A. ADMINISTRATIVE REPORT & DECISION

DECISION:	<input type="checkbox"/> APPROVED	<input checked="" type="checkbox"/> APPROVED SUBJECT TO CONDITIONS	<input type="checkbox"/> DENIED
REPORT DATE:	November 8, 2016		
Project Name:	Dylan Short Plat		
Owner/Applicant:	Kenneth E. Neault, P.O. Box 2230, Issaquah, WA 98027		
Contact:	Jae Kim, Encompass Engineering & Surveying, Inc., 165 NE Juniper St., Ste. 201 Issaquah, WA 98027		
File Number:	LUA16-000754, SHPL-A		
Project Manager:	Clark H. Close, Senior Planner		
Project Summary:	<p>The applicant is requesting approval of a 2-lot short plat. The site is 22,912 square feet (0.53 acres) and is located at 1909 Jones Ave NE (APN 3344500120) and would be for the future development of one new single family home. The property is in the Residential-4 (R-4) zoning district. The proposed residential lots are approximately 9,993 SF and 10,732 SF in area with an average lot size of 10,363 SF. The residential density is 4.2 dwelling units per net acre. Access is proposed from a shared driveway tract from Jones Ave NE along the north property line. A second driveway approach is proposed to be retained to the existing single family home. The native soil

PRELIMINARY LANDSCAPE PLAN

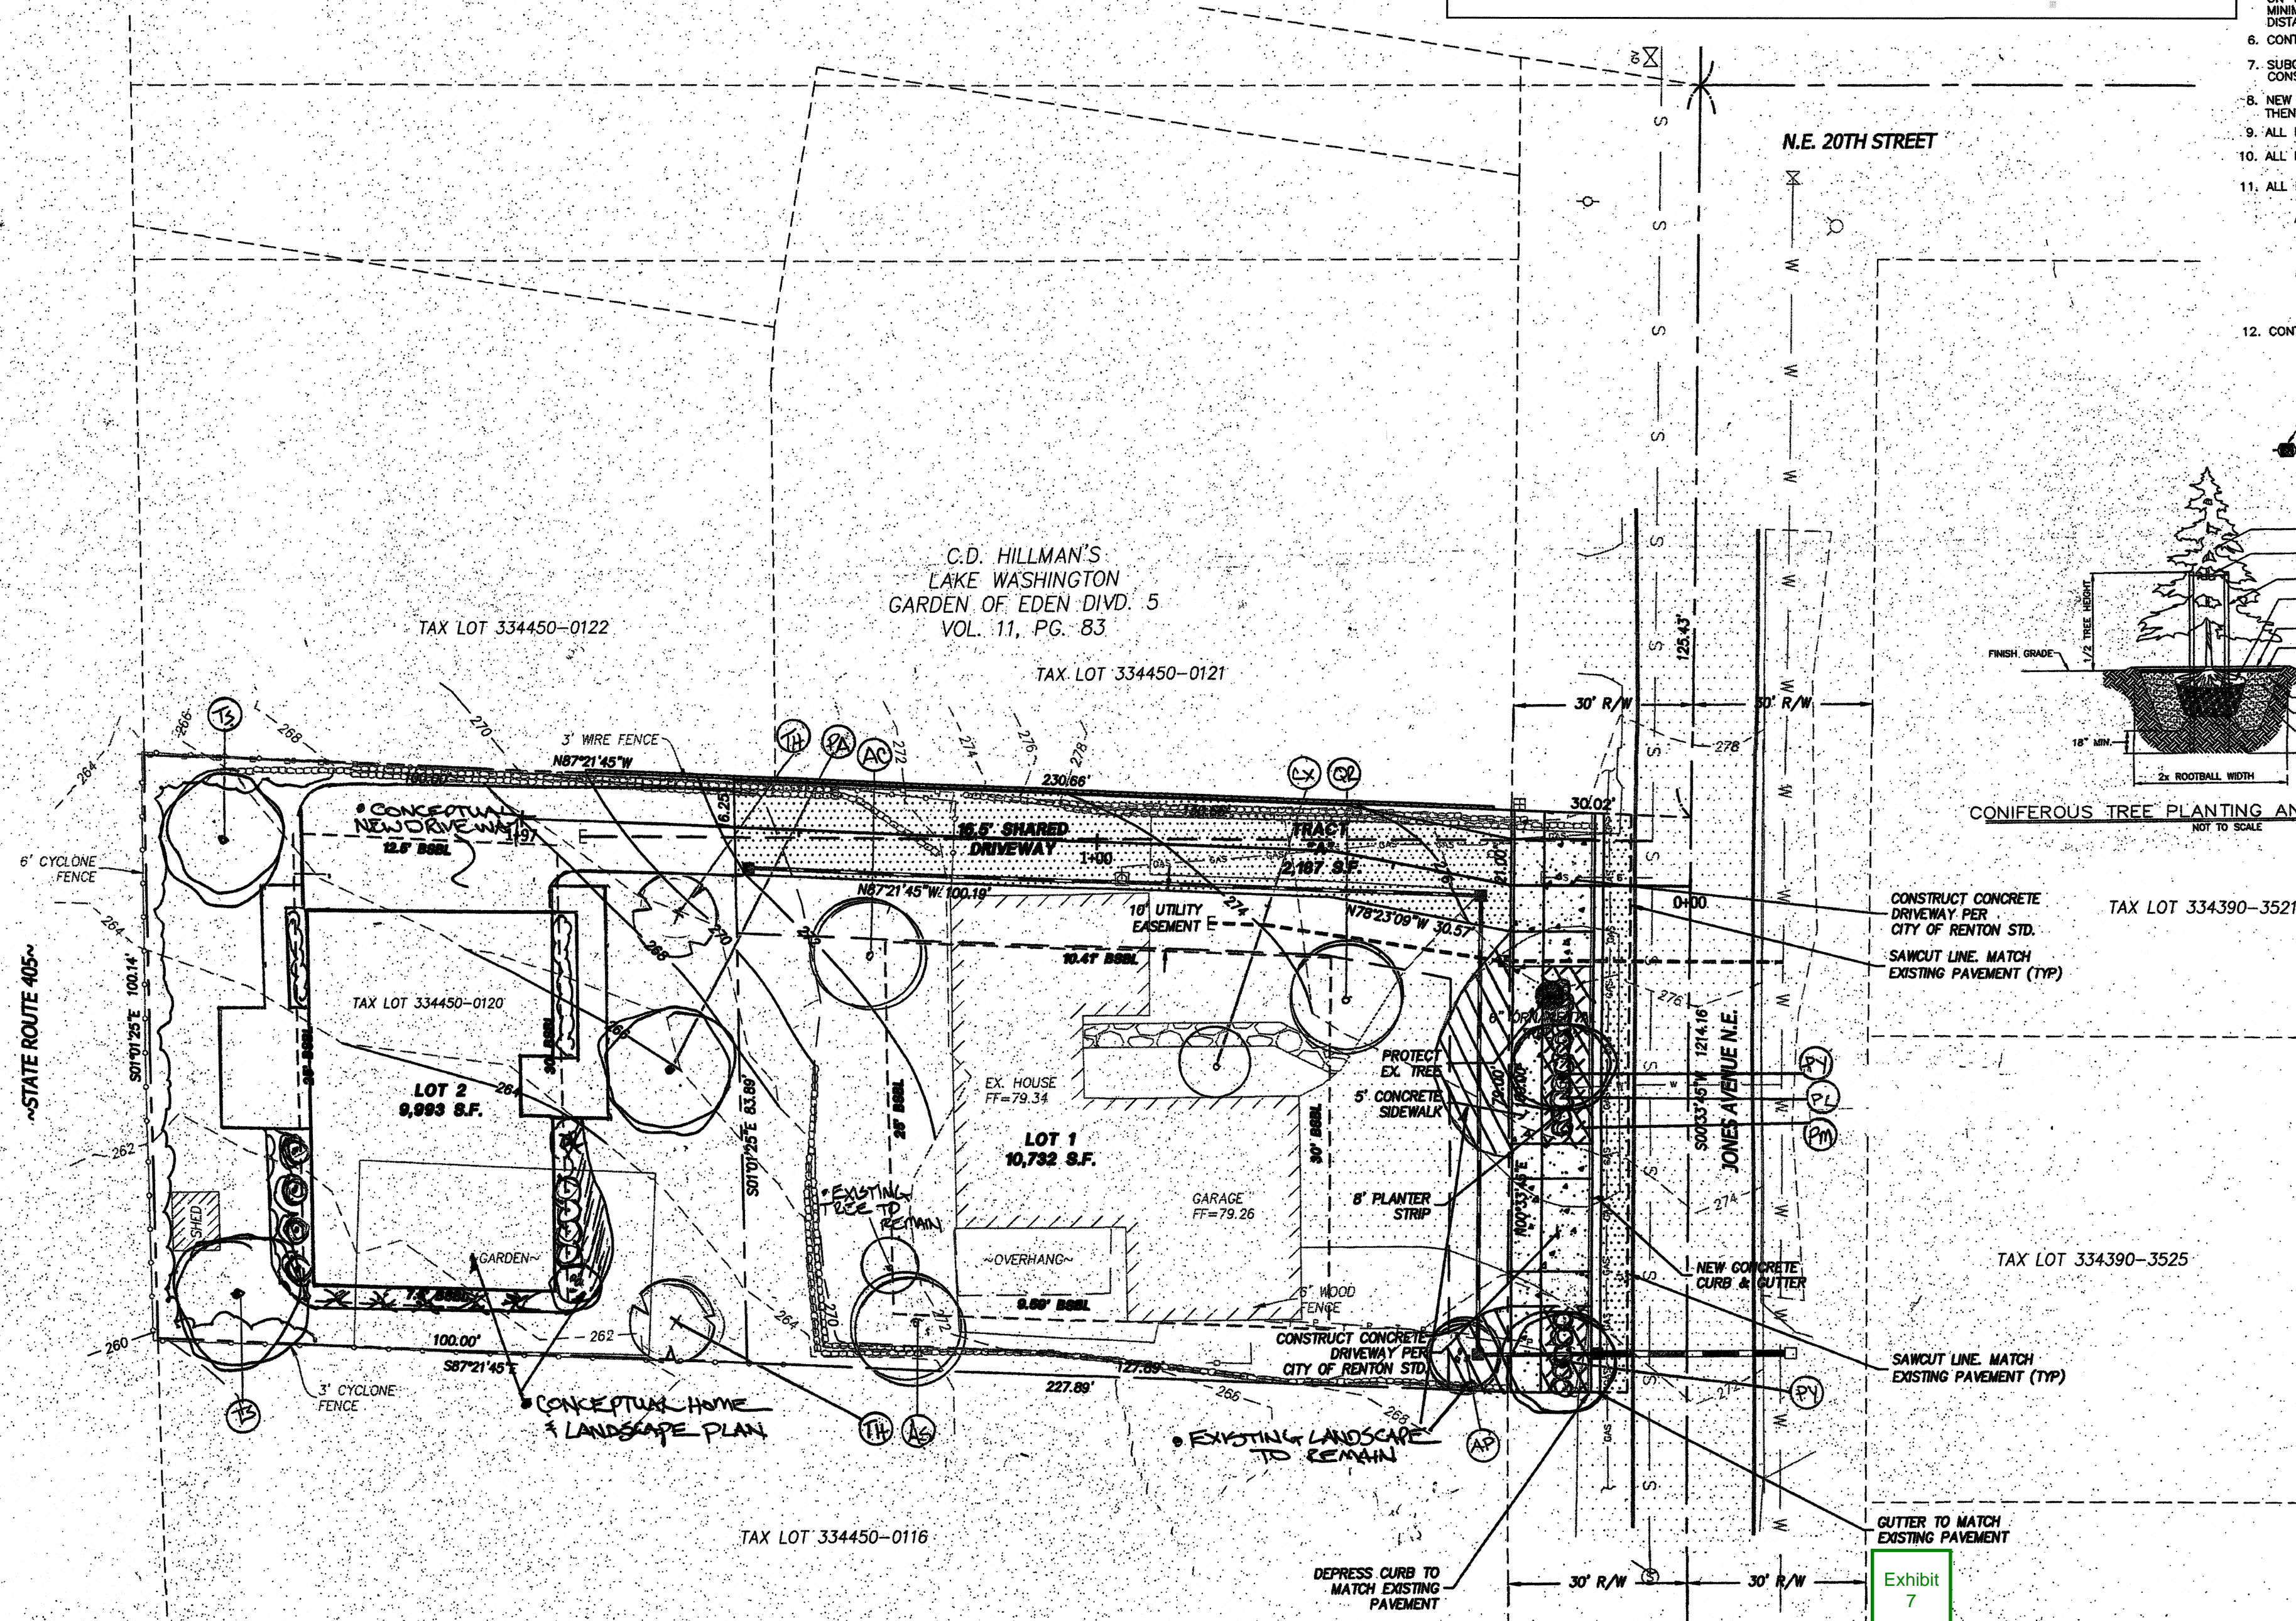
<p>7), was submitted with the short plat application materials. A partial 10-foot onsite landscape strip is proposed along the street frontage of Jones Ave NE. A Plant Schedule was included on the Landscape Plan, the following trees and plants are proposed within the onsite landscape strip and right-of-way planter strip: Yoshino Cherry, Otto Luyken Laurel, Mt. Vernon Laurel, Japanese Maple, Regal Prince Oak, Starlight Dogwood, Crimson King Maple, Sycamore Maple, Hogan Cedar, Akebono Cherry, and Sterling Silver Linden. Staff recommends, as a condition of approval, that the applicant submit a final detailed landscape plan that complies with RMC 4-8-120D.12 at the time of utility construction permit application to the current planning project manager for review and approval.</p> <p>The applicant would be required to record a note on the face of the plat that executes a shared maintenance agreement for equal ownership and maintenance responsibilities for improvements in Tract A. A draft version of a shared maintenance agreement shall be submitted for review and approval by the current planning project manager prior to short plat recording.</p> <p>If the applicant creates a home owners association for ownership and maintenance responsibilities for improvements in Tract A, then HOA documents shall be submitted for review and approval by the current planning project manager and the City Attorney prior to short plat recording.</p>

✓	<p>Tree Retention: The City's adopted Tree Retention and Land Clearing Regulations require the retention of 30 percent of trees in a residential development.</p> <p>Significant trees shall be retained in the following priority order:</p> <p>Priority One: Landmark trees; significant trees that form a continuous canopy; significant trees on slopes greater than twenty percent (20%); Significant trees adjacent to critical areas and their associated buffers; and Significant trees over sixty feet (60') in height or greater than eighteen inches (18") caliper.</p> <p>Priority Two: Healthy tree groupings whose associated undergrowth can be preserved; other significant native evergreen or deciduous trees; and Other significant non- native trees.</p> <p>Priority Three: Alders and cottonwoods shall be retained when all other trees have been evaluated for retention and are not able to be retained, unless the alders and/ or cottonwoods are used as part of an approved enhancement project within a critical area or its buffer.</p> <p>A minimum tree density shall be maintained on each residentially zoned lot. For detached single family development, the minimum tree density is two (2) significant trees for every five thousand (5,000) square feet. The tree density may consist of existing trees, replacement trees, trees required pursuant to RMC 4-4-070F.1, Street Frontage Landscaping Required, or a combination.</p> <p><u>Staff Comment:</u> A Conceptual Landscaping Plan (Exhibit 7) was submitted with the project application materials. According to the Plan, a single 14" ornamental tree is proposed to be retained onsite. No other significant trees were located onsite. As a result, the applicant is proposing to retain 100 percent of the significant trees, thereby, meeting the minimum tree retention requirements of the R-4 zone.</p> <p>In addition, to complying with the minimum tree density requirements, the applicant is required to retain or plant two (2) significant trees, or gross equivalent caliper inches, per 5,000 square feet of lot area. Based on the lot areas proposed, the applicant would be required to plant three (3) additional trees on Lot 1 in order to meet minimum tree density requirements and four (4) trees on Lot 2. The conceptual</p>

<i>Landscape Plan demonstrates compliance with minimum tree density and tree retention requirements of the zone by providing more than four (4) new trees per lot. Onsite landscaping shall be installed prior to final occupancy for the individual homes, landscaping within the right-of-way shall be installed prior to short plat recording.</i>
Compliant if conditions of approval are met	<p>Parking: Parking regulations require that a minimum of two (2) parking spaces be provided for each detached dwelling.</p> <p>Driveway cuts are required to be a minimum of 5 feet from property lines and new driveways may be a maximum of 16 feet in width at the property line. Maximum driveway slopes shall not exceed fifteen percent (15%); provided, that driveways exceeding eight percent (8%) shall provide slotted drains at the lower end with positive drainage discharge to restrict runoff from entering the garage/residence or crossing any public sidewalk.</p> <p><u>Staff Comment:</u> <i>The shared driveway has a slope less than 5 percent (5%). The shared driveway transitions into a future driveway on Lot 2. The slope of the future driveway on Lot 2 was identified as 12.58%, which exceeds eight percent (8%); therefore, the applicant would be required to provide slotted drains at the lower end with positive drainage discharge to restrict runoff from entering the garage/residence (Exhibit 6). Parking requirements and driveway grades for each of the new residences proposed would be verified at the time of building permit review. The shared driveway cut for Tract A is located a minimum of 5 feet from the north property line. The applicant is proposing to retain the existing driveway approach on Lot 1, which is located approximately 14 feet north of the south property line. The proposed single family driveway measures 16 feet wide at the property line. As a condition of approval, staff is recommending a reduction to the single family driveway measurement of 16 feet to 9 feet wide at the property line. See FOF 16 Compliance with Subdivision Regulations: Access for analysis.</i></p>

2. The applicant shall submit a detailed landscape plan that complies with RMC 4-8-120D.12 at the time of utility construction permit application to the current planning project manager for review and approval. Landscaping within the right-of-way and landscaping within the 10-foot wide landscape strip on Lot 1 shall be installed prior to short plat recording. Onsite landscaping for Lot 2 shall be installed prior to final occupancy for the single family building permit.

STD. PLAN - 104.3

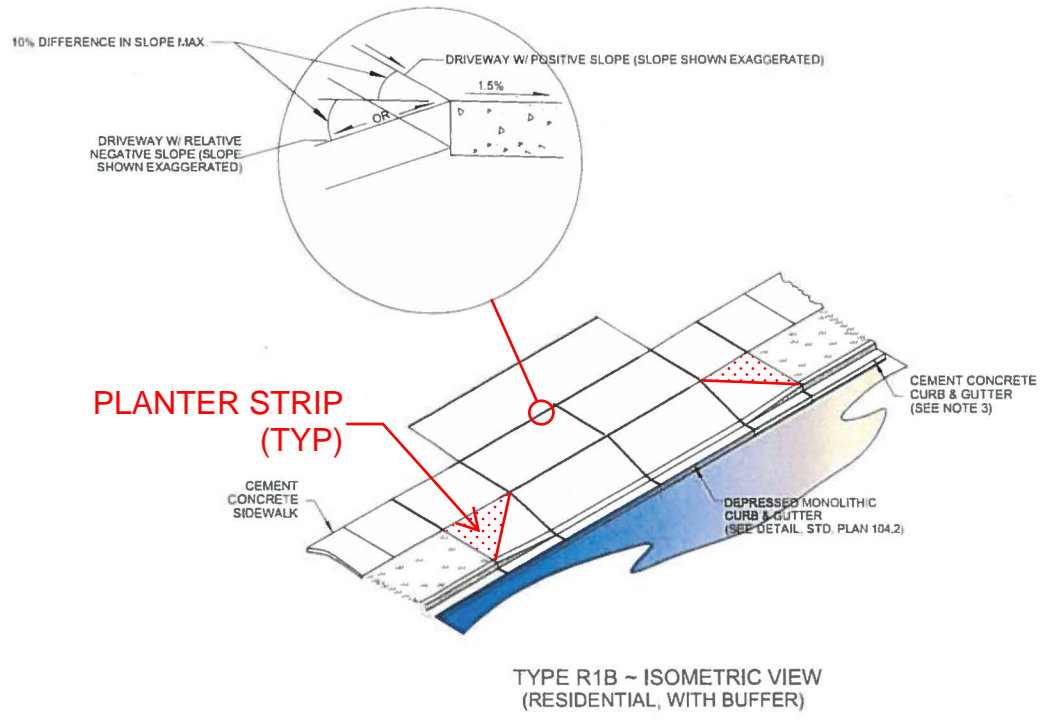
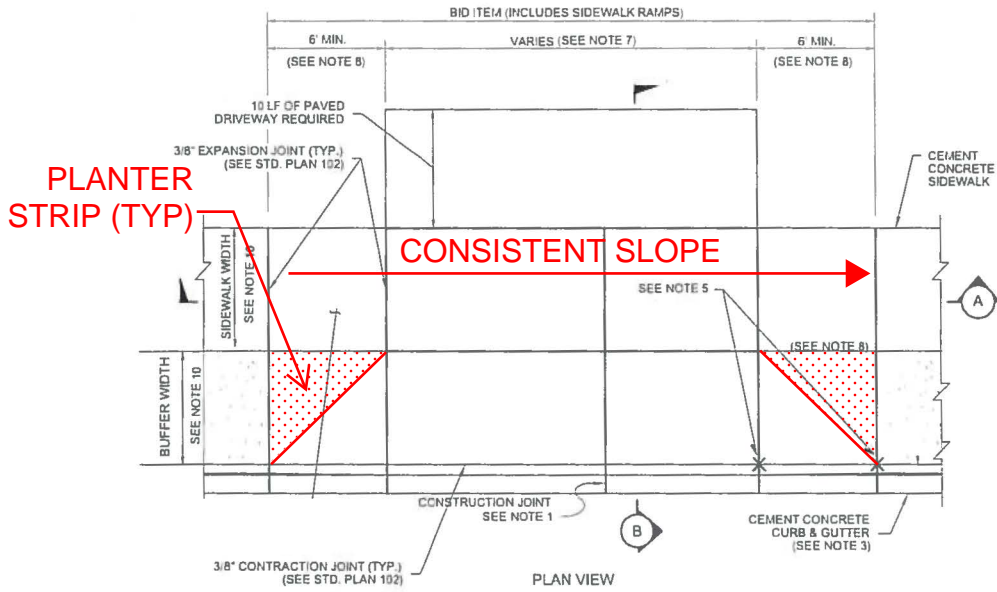
<i>Driveways shall be designed in accordance with Modified City Standard Plans 104.3 (RMC 4-4-080; Exhibit 14). A construction permit for frontage improvements would be required.</i>
N/A	Blocks: Blocks shall be deep enough to allow two tiers of lots. <i>Staff Comment:</i> No blocks are proposed.
✓	Lots: The size, shape, orientation, and arrangement of the proposed lots comply with the requirements of the Subdivision Regulations and the Development Standards of the R-4 zone and allow for reasonable infill of developable land. All of the proposed lots meet the requirements for minimum lot size, depth, and width. <i>Staff Comment:</i> As discussed above under FOF 13 all lots meet the minimum lot dimensional requirements in the R-4 zone. The proposed lots are rectangular in shape. The orientations of the lots have their front yards facing east towards Jones Ave NE. Access to the existing single family home would retain orientation and access to Jones Ave NE via the existing paved driveway. The building design of the new residence would be reviewed and approved at the time of building permit application.

4. The applicant shall be limited to single loaded garage driveway cut, not to exceed nine feet (9') in width, at the property line along Jones Ave NE to serve the existing single family home on Lot 1. A plat note to this effect shall be added to the face of the final short plat. A final detailed site plan shall be submitted to and approved by the City of Renton Project Manager prior to construction permit approval.
